Glennstone Phase 3 Dry Pond 3

(City of Durham ID# 00410)

Annual Certification Inspection Journal (ACIJ) – Interim Report

TRAC-2020-07-01

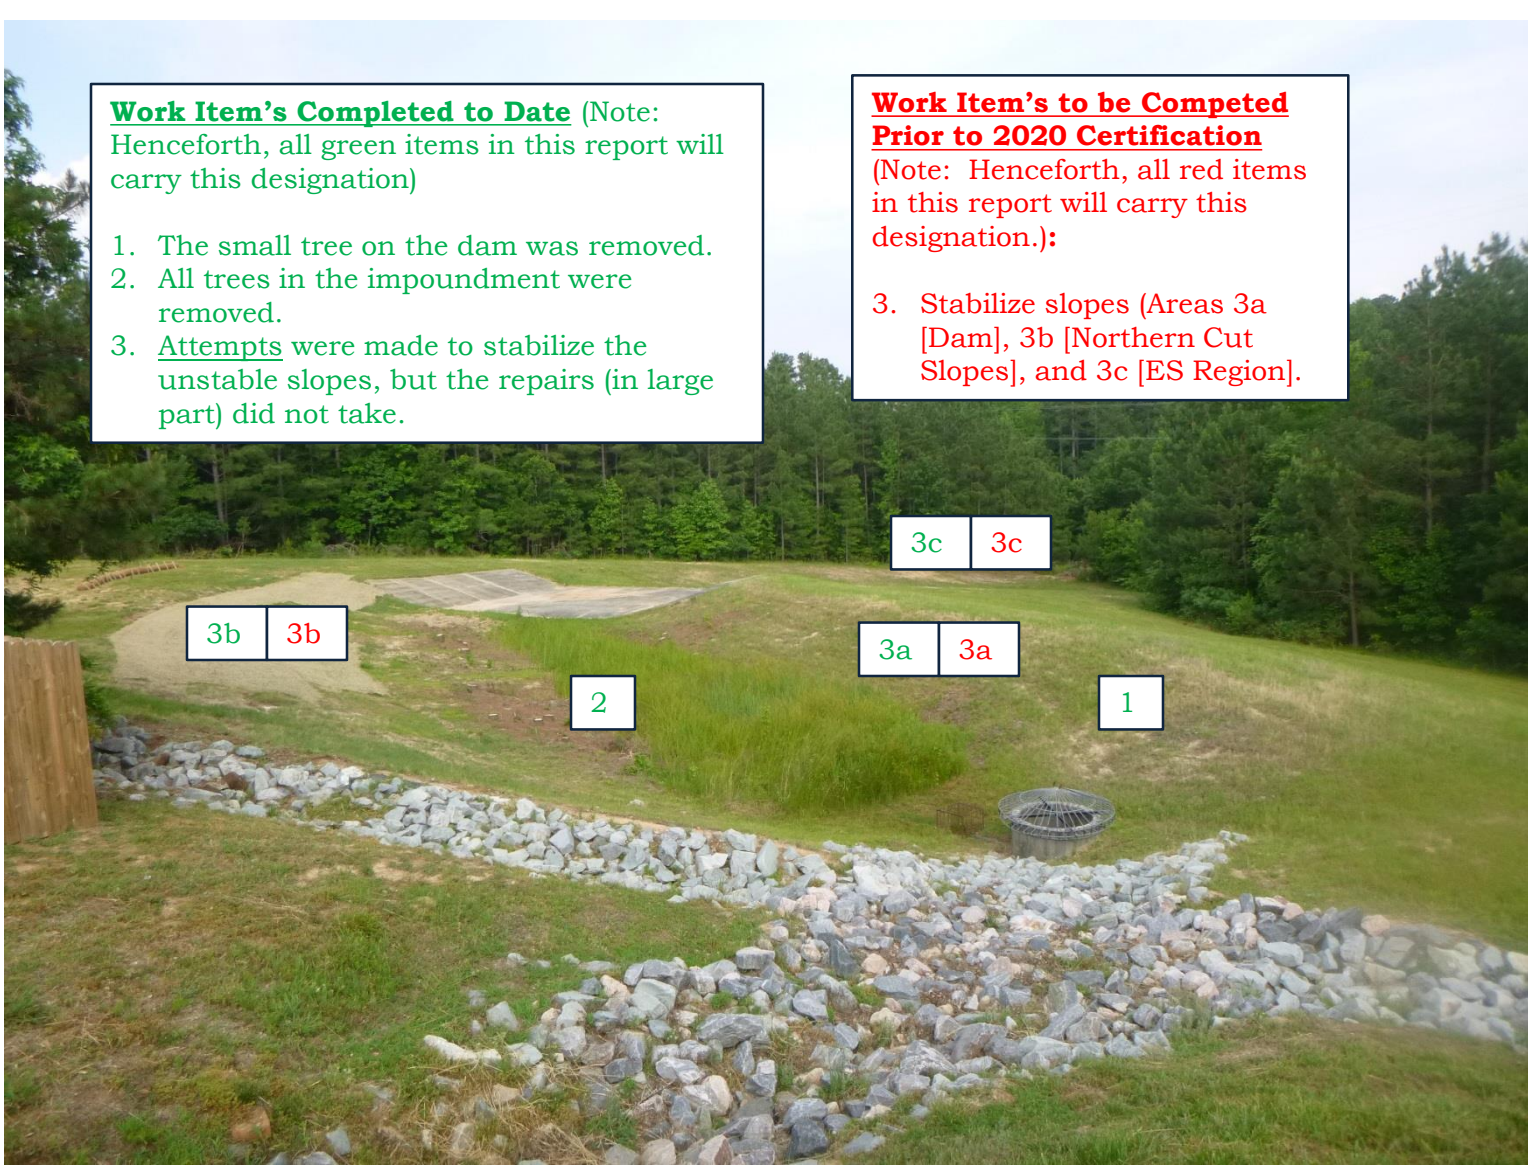
1. The small tree on the dam was removed.
2. All trees in the impoundment were removed.
3. Attempts were made to stabilize the unstable slopes, but the repairs (in large part) did not take.

3. Stabilize slopes (Areas 3a [Dam], 3b [Northern Cut Slopes], and 3c [ES Region]).

PF: Stabilize all bare and eroded areas with turf grass.

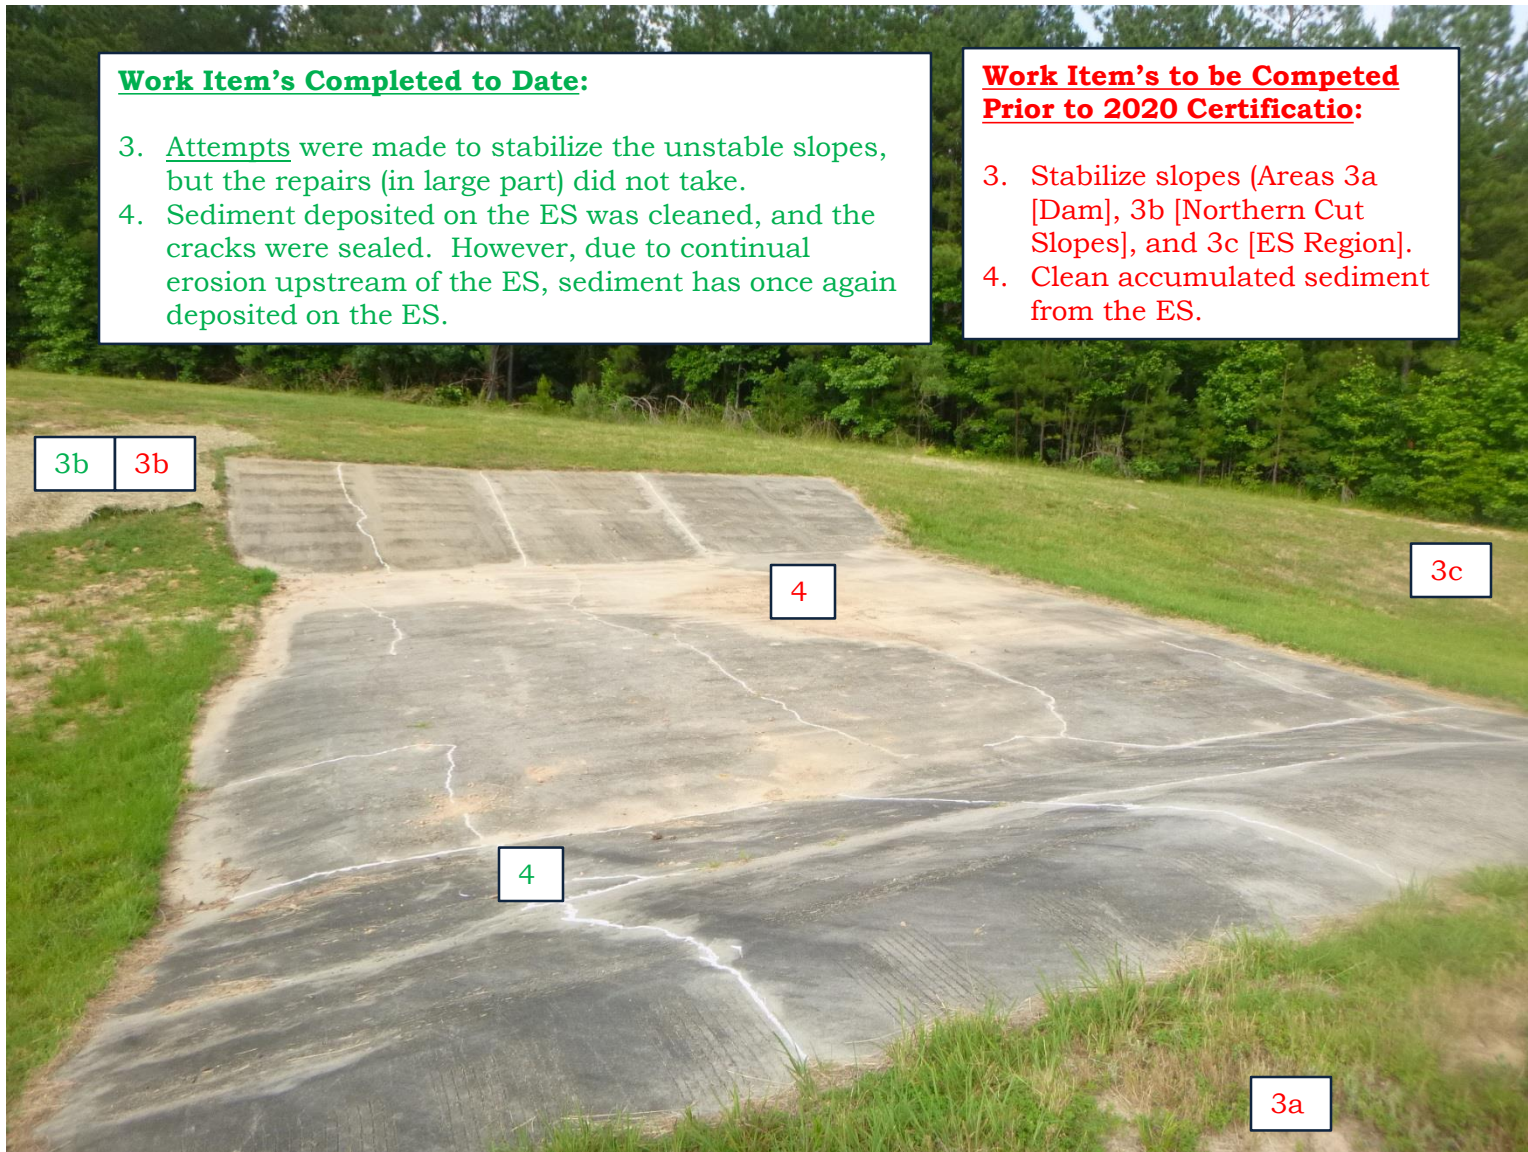
- 3. Attempts were made to stabilize the unstable slopes, but the repairs (in large part) did not take.
- 4. Sediment deposited on the ES was cleaned, and the cracks were sealed. However, due to continual erosion upstream of the ES, sediment has once again deposited on the ES.

- 3. Stabilize slopes (Areas 3a [Dam], 3b [Northern Cut Slopes], and 3c [ES Region]).
- 4. Clean accumulated sediment from the ES.

PF: Stabilize all bare and eroded areas with turf grass.

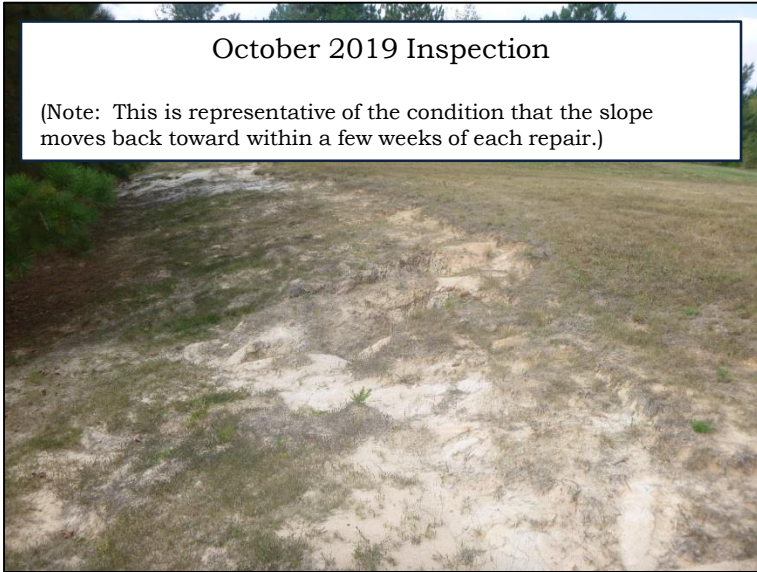
(Note: This is representative of the condition that the slope moves back toward within a few weeks of each repair.)

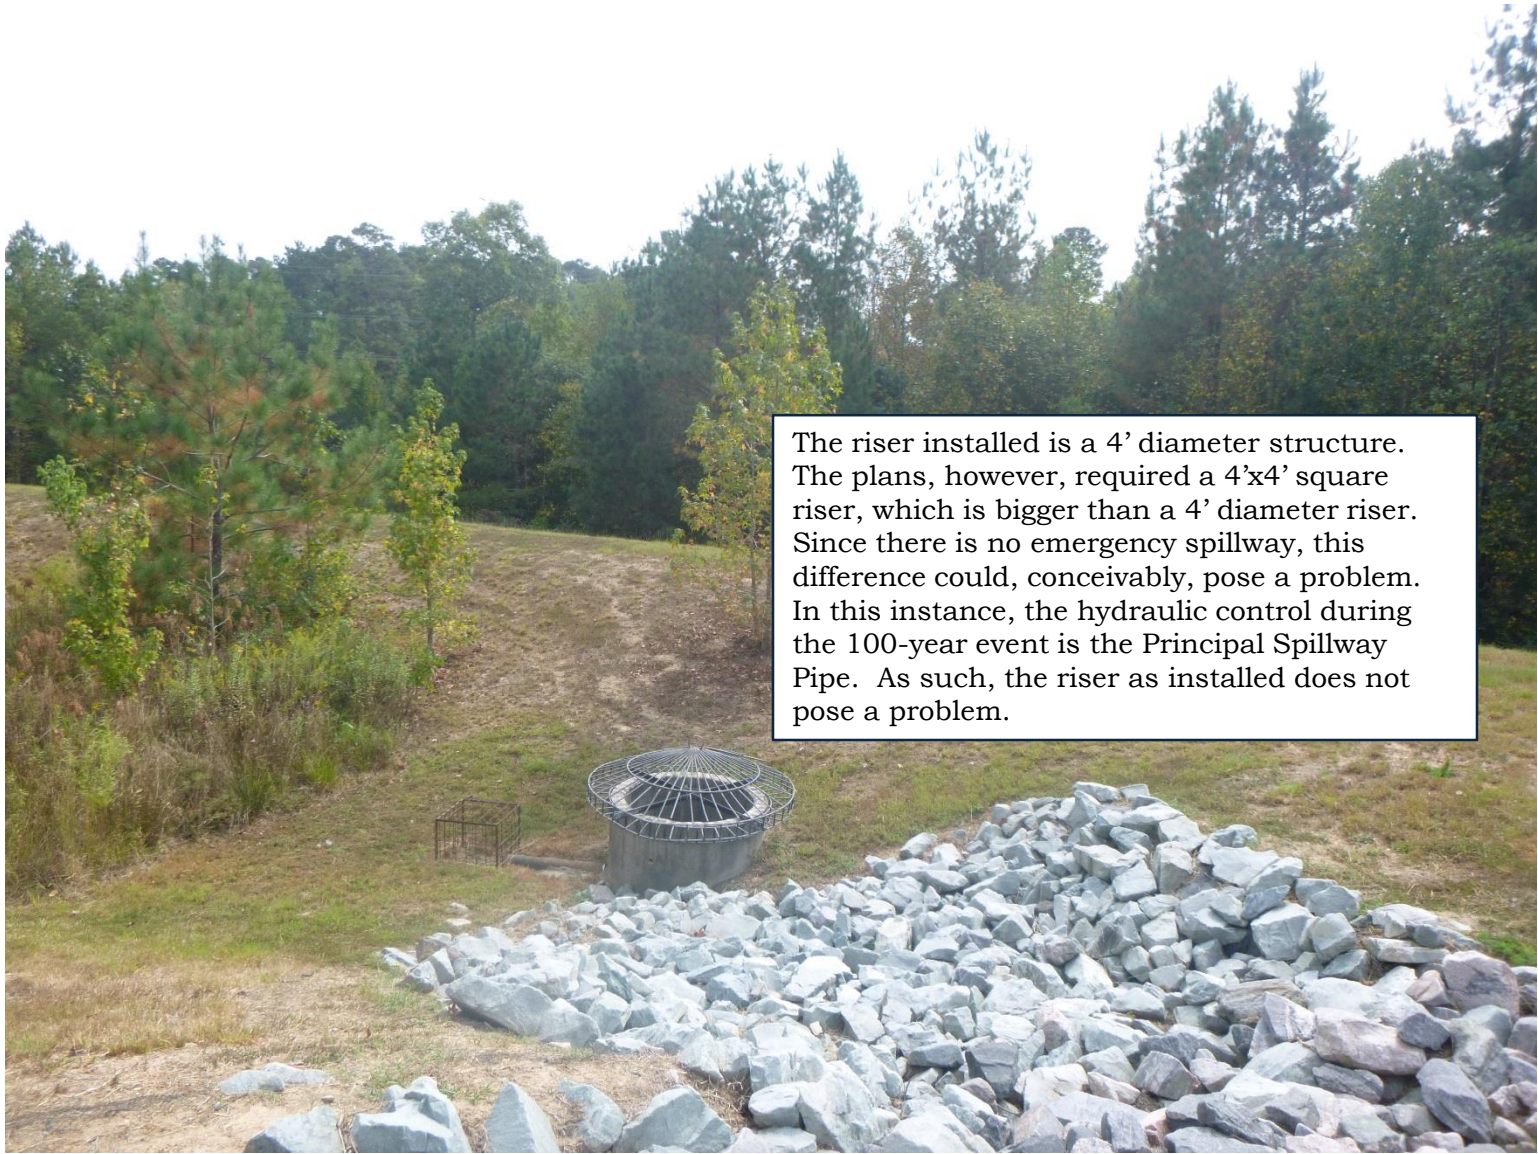
The riser installed is a 4' diameter structure. The plans, however, required a 4'x4' square riser, which is bigger than a 4' diameter riser. Since there is no emergency spillway, this difference could, conceivably, pose a problem. In this instance, the hydraulic control during the 100-year event is the Principal Spillway Pipe. As such, the riser as installed does not pose a problem.

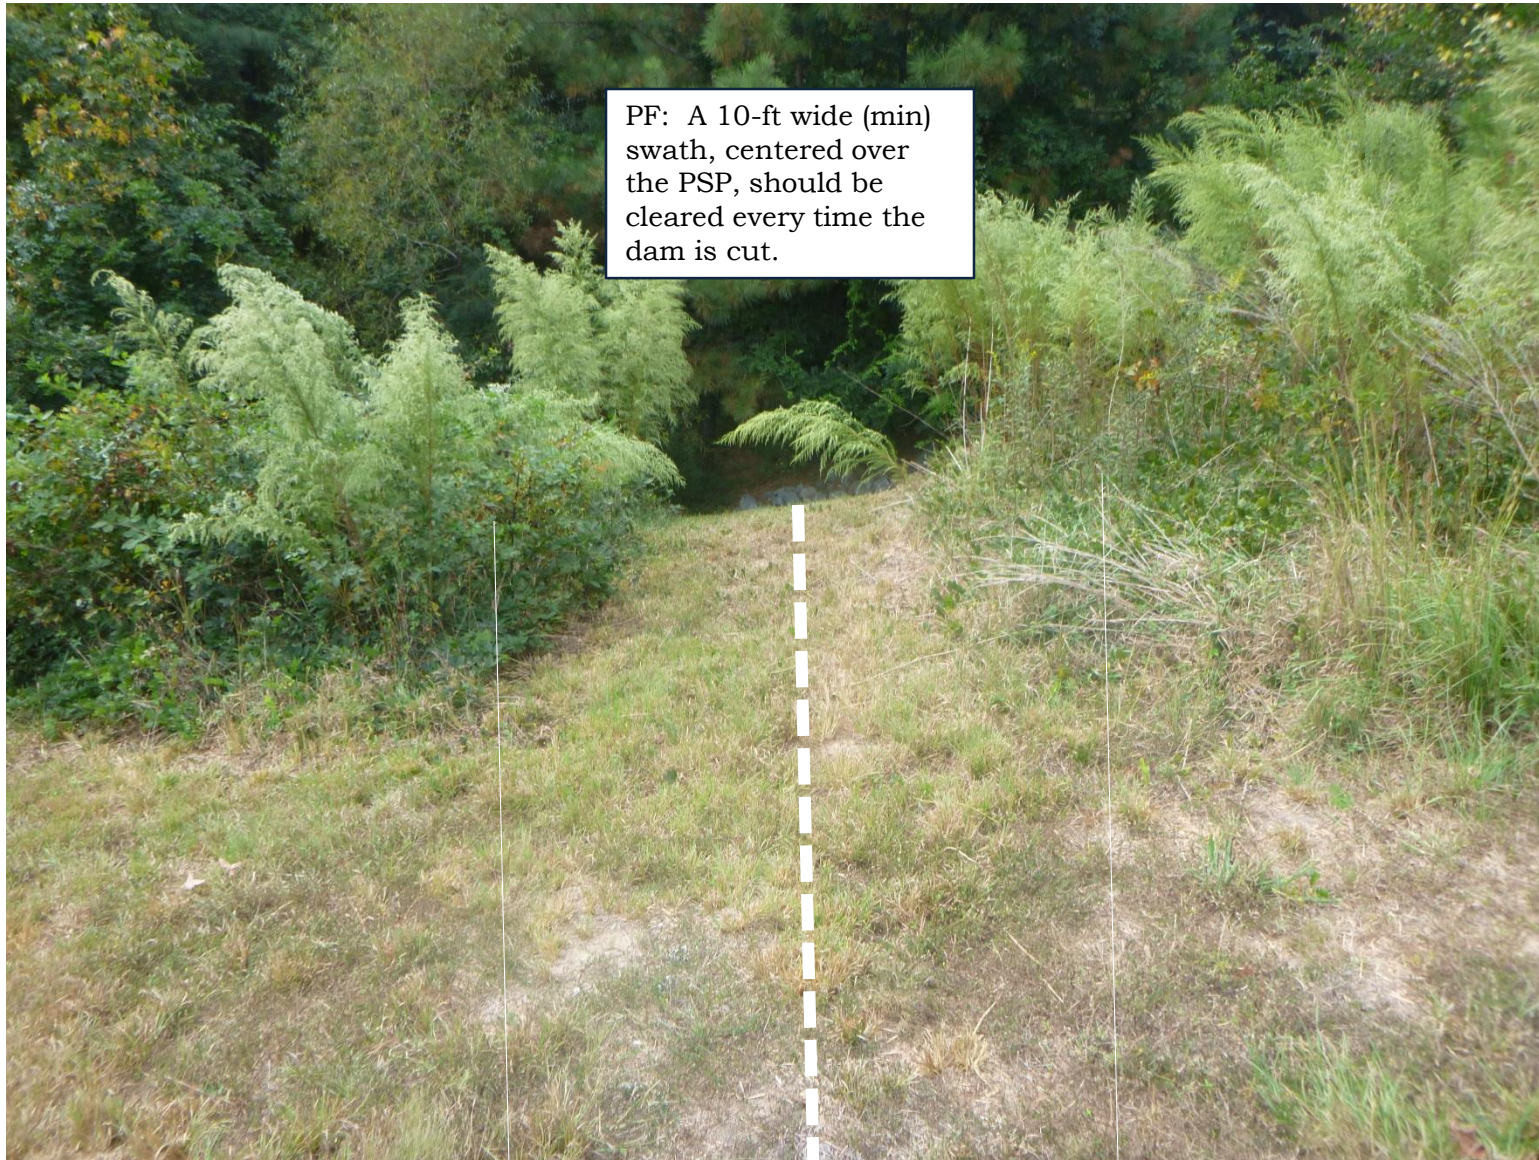
PF: A 10-ft wide (min) swath, centered over the PSP, should be cleared every time the dam is cut.

6. Clear a 10-ft wide (min) swath, centered over the PSP.

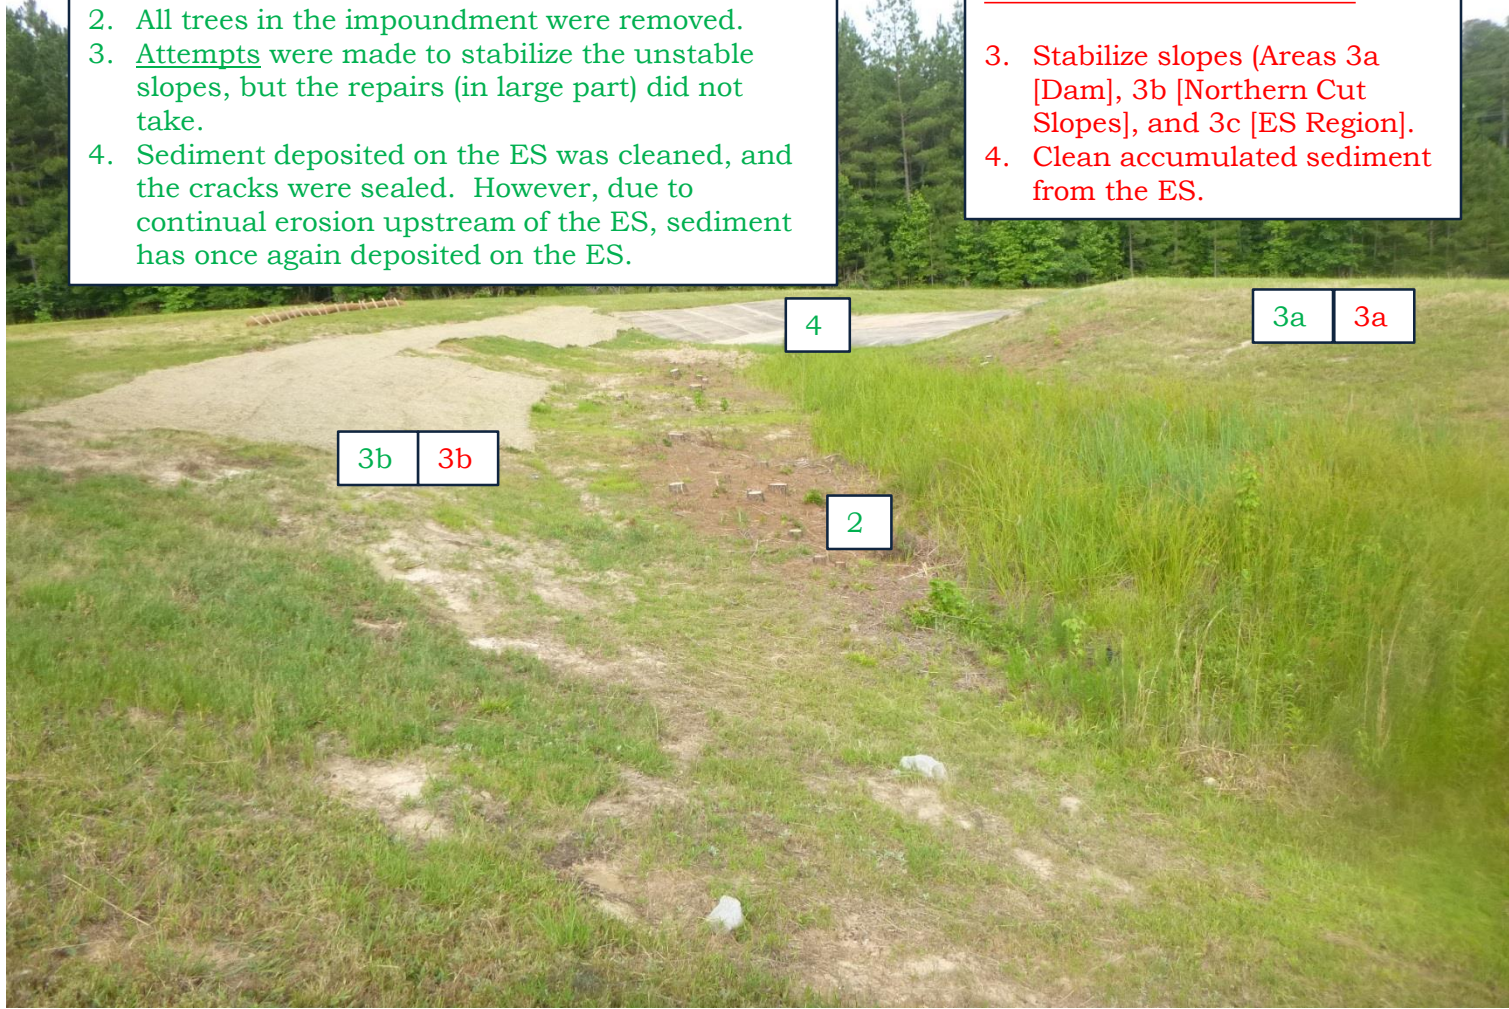
2. All trees in the impoundment were removed.
3. Attempts were made to stabilize the unstable slopes, but the repairs (in large part) did not take.
4. Sediment deposited on the ES was cleaned, and the cracks were sealed. However, due to continual erosion upstream of the ES, sediment has once again deposited on the ES.

3. Stabilize slopes (Areas 3a [Dam], 3b [Northern Cut Slopes], and 3c [ES Region]).
4. Clean accumulated sediment from the ES.
